BG96 R1.0 & BG96 R1.2

Differences Statement

PCB Rev.: R1.2

Ref: FCC Class II Permissive change for FCC ID: XMR201707BG96
Original Grant Date: 07/20/2017
Class II Grant Date: 09/12/2017
Applicant: Quectel Wireless Solutions Co., Ltd

Figure 1: Schematic Designs of BG96 R1.1 and R1.2

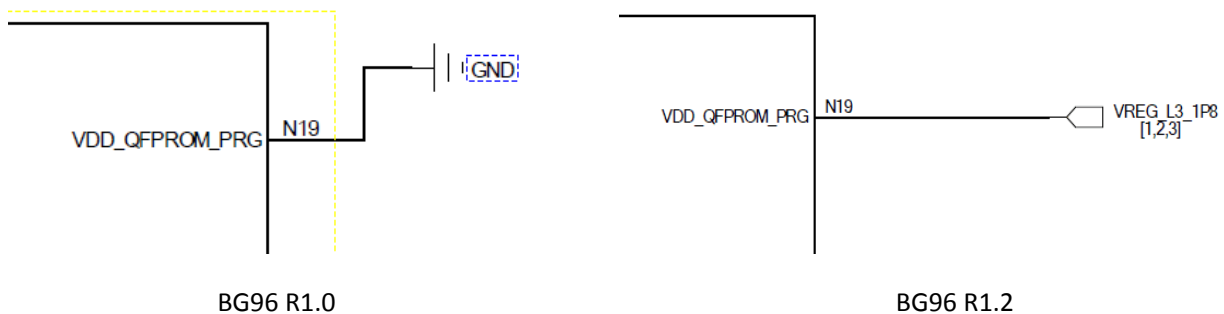
The VDD_QFPROM_PRG (N19) pin of baseband chip is for secure boot function. In BG96 R1.1, this pin is connected to ground directly, which means secure boot function is disabled.

According to Qualcomm's suggestion and our customers' requirements, the VDD_QFPROM_PRG pin is connected to VREG_L3_1P8(1.8V) in BG96 R1.2 so as to enable secure boot function.

Figure 2: PCB Designs of BG96 R1.0 and R1.2

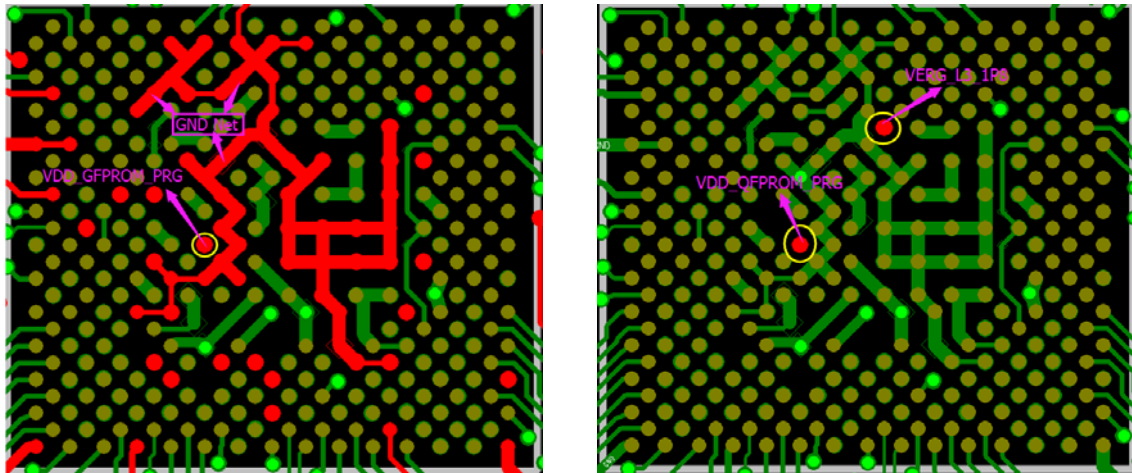
Based on BG96 R1.0, BG96 R1.2 has enabled VDD_QFPROM_PRG hardware interface, which is connected to ground directly in BG96 R1.1, so as to support secure boot feature.
